SUBJECT: COMANCHE PEAK STEAM ELECTRIC STATION
DOCKET NOS. 50-445 AND 50-446
SUPPLEMENT TO LICENSE AMENDMENT REQUEST (LAR) 07-004
REVISION TO THE OPERATING LICENSE AND TECHNICAL SPECIFICATION 1.0,
"USE AND APPLICATION" TO REVISE RATED THERMAL POWER FROM 3458 MWT
TO 3612 MWT
(TAC NOS. MD6615 AND MD6616)

RESPONSE TO REQUEST FOR ADDITIONAL INFORMATION

Figure 2.8.5.4.2-25 Bank Withdrawal at Power – Unit 2, Maximum Reactivity Feedback – 100% Power – 1 pcm/sec - Nuclear Power and Core Heat Flux Versus Time

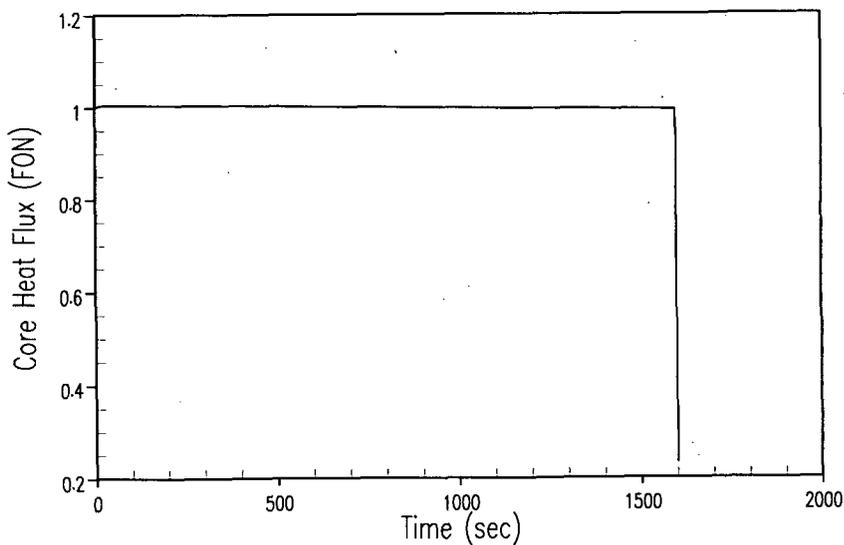
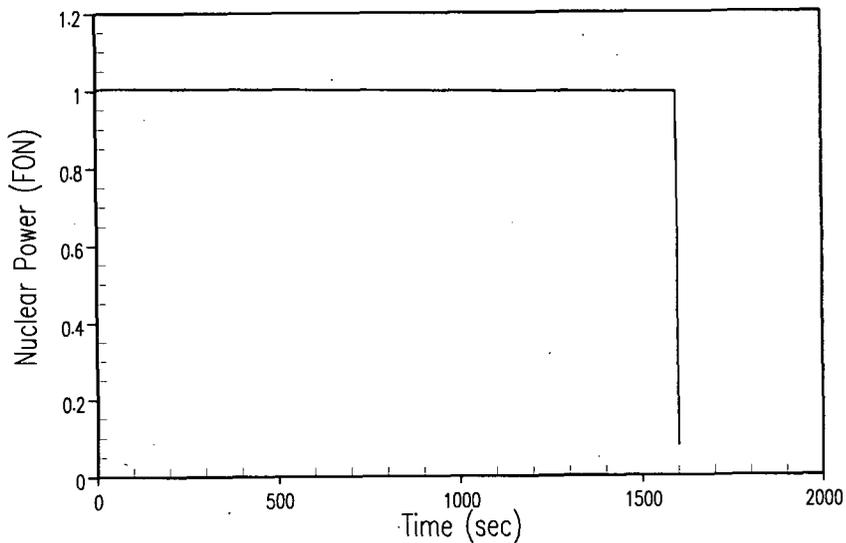
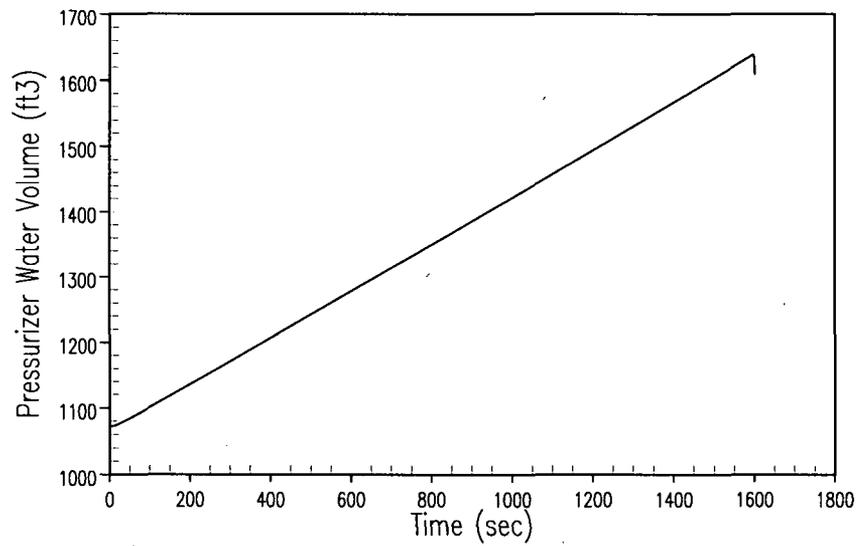
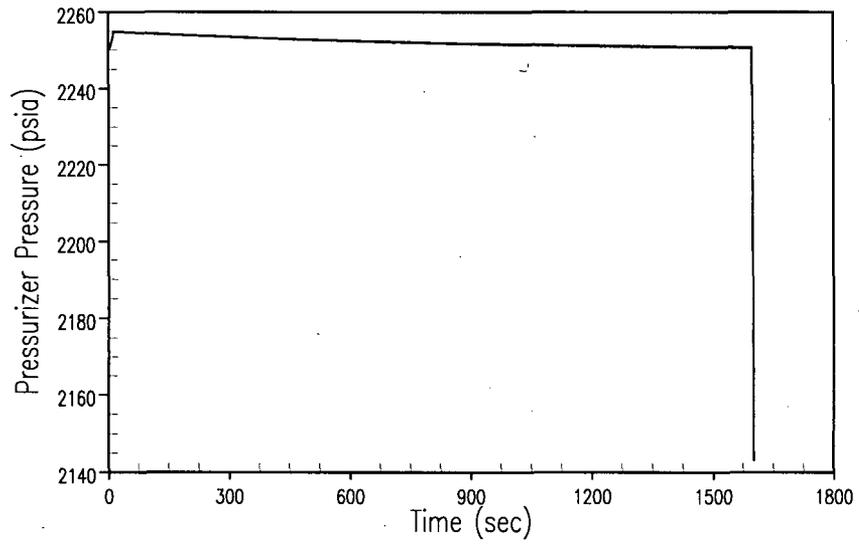
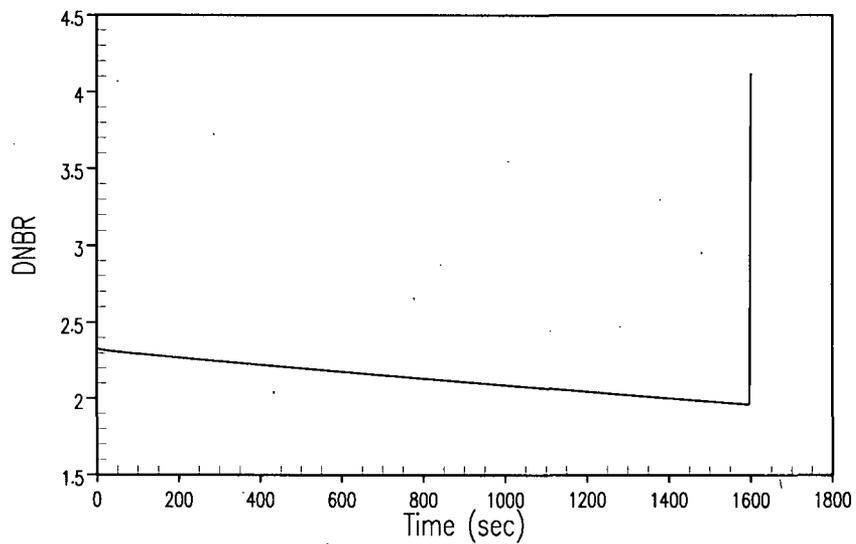
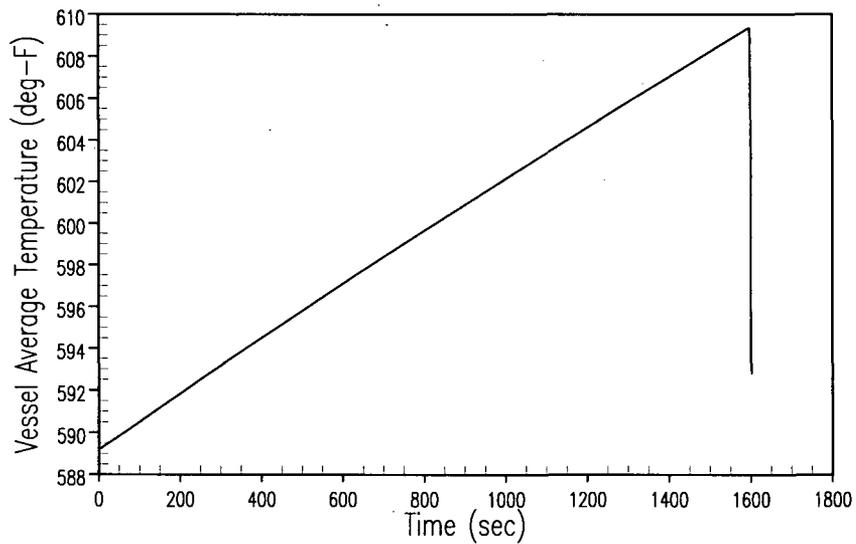
The SPULR states that two cases for minimum and maximum reactivity feedback were analyzed. The staff was unable to locate the results for the maximum reactivity feedback case. Provide these results.

The requested results are provided in the attached revision to Section 2.8.5.4.2 (Uncontrolled Rod Cluster Control Assembly Bank Withdrawal at Power). This section was recently revised to address some isolated issues related to the corresponding analysis. As the revised analysis affected results that were presented in Table 2.8.5.0-1, Table 2.8.5.4.2-1, and Table 2.8.5.4.5-1 (Boron Dilution) of the licensing report, revised tables are also provided (See Attachments 2 and 3).

Figures 2.8.5.4.2-7 through 2.8.5.4.2-9 (Unit 1) and Figures 2.8.5.4.2-22 through Figures 2.8.5.4.2-24 for (Unit 2) show the transient response for a rapid uncontrolled RCCA bank withdrawal incident (110 pcm/sec) starting from 100 percent power with maximum reactivity feedback. The transient response for a slow uncontrolled RCCA bank withdrawal (1 pcm/sec) from 100 percent power with maximum feedback is shown in Figures 2.8.5.4.2-10 through 2.8.5.4.2-12 (Unit 1) and Figures 2.8.5.4.2-25 through 2.8.5.4.2-27 (Unit 2). The results are similar to the results of the cases with minimum reactivity feedback, but the maximum reactivity feedback leads to a slower increase in power, resulting in a longer transient.
